September 10, 2021

Re: Sierra Club Comments on Draft CCR Closure Permit No. 057-026D (CCR) to Georgia Power Plant Hammond Inactive CCR Surface Impoundment AP-3

Figure 3. Details of proposed sinkhole repair

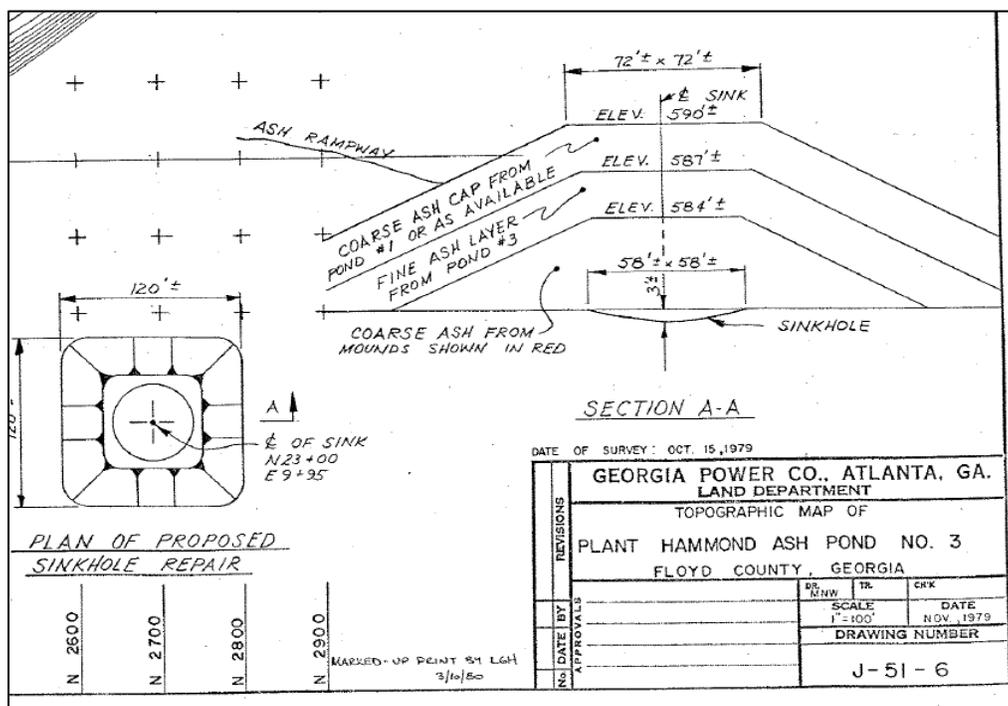
In addition to the 1977 sinkhole event, approximately two years later, there is evidence of a *second* sinkhole under AP-3, 58 feet in diameter.⁴⁶ Again, Georgia Power failed to mention or disclose this *second* sinkhole in its application other than to include a design drawing (over 1200 pages into its application) dated November 1979 showing a “Plan for Proposed Sinkhole Repair,” as shown in Figure 3.⁴⁷

Figure 4. 1977 sketch of borings showing voids in the bedrock beneath AP-3 that have formed from limestone dissolution that were known before AP-3 was initiated.⁵⁰

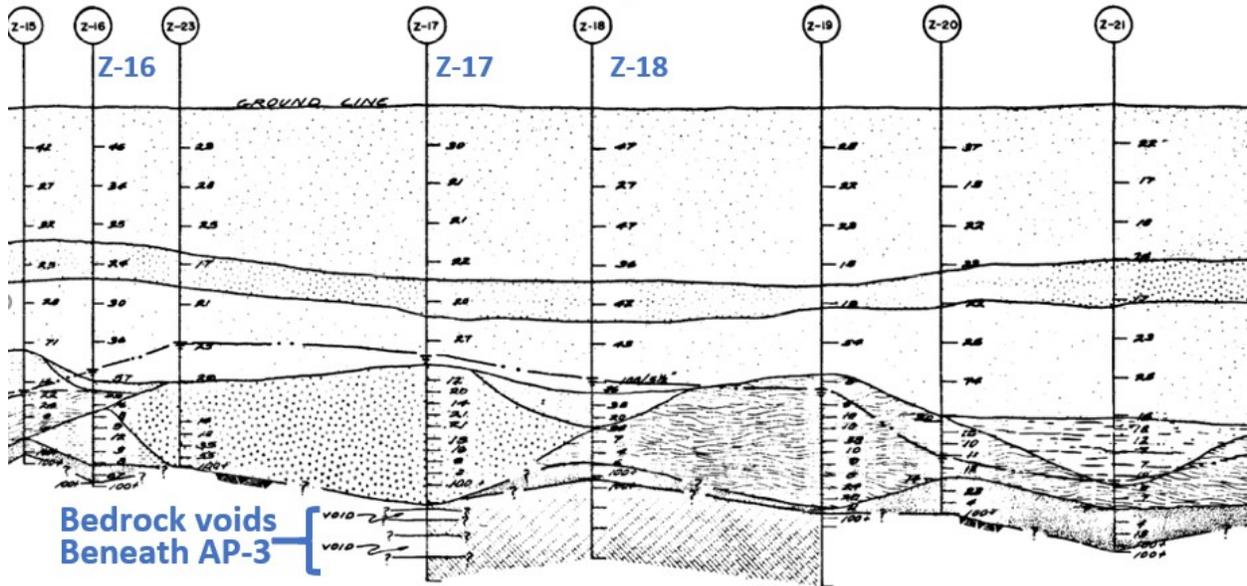
Borings taken before AP-3 became operational in June 1977 show several voids, or spaces, in the bedrock beneath AP-3, as shown in Figure 4, indicating heterogeneity in the bedrock and the presence of karst.⁴⁹ A fact known to Georgia Power *prior to* when AP-3 began receiving CCR.

Figure 5. West to East Cross Section of AP-3.⁶⁸

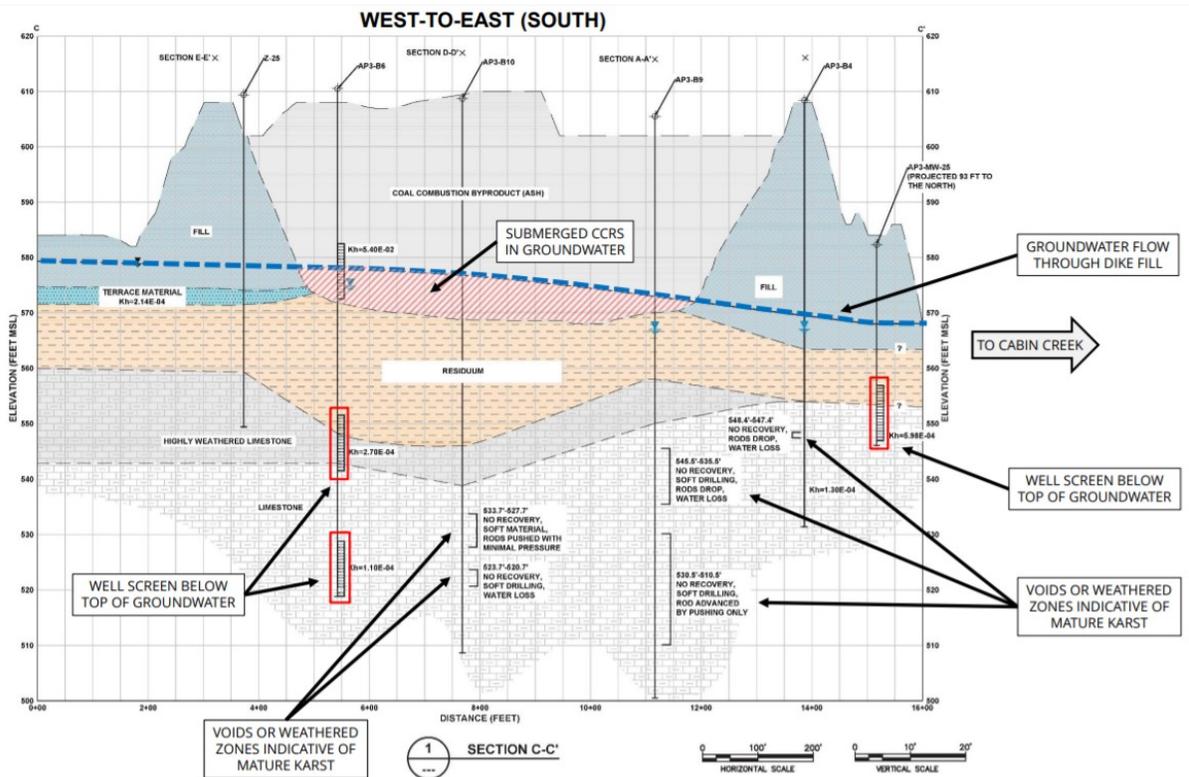
Federal and state law require that a CCR surface impoundment be placed at least five feet above the uppermost aquifer, or that the owner or operator must show that there is no intermittent or sustained hydraulic connection between the CCR surface impoundment and the aquifer.⁶⁵ Georgia Power admits that, because the groundwater infiltrates AP-3, AP-3 does not satisfy the aquifer location restriction under federal and state law.⁶⁶ As shown in Figure 5, the CCRs contained in AP-3 are saturated in groundwater and are within the uppermost aquifer.⁶⁷

Because AP-3 was constructed using excavated sandy, clayey and gravelly soil from within AP-3, those types of soils, which are permeable, make it easier for CCR contaminants to be transported into groundwater through the dikes and the bottom of AP-3.⁶⁹ This is evident by Georgia Power’s recent borings into AP-3, which shows saturated CCRs 40 years after they converted to dry ash handling.⁷⁰
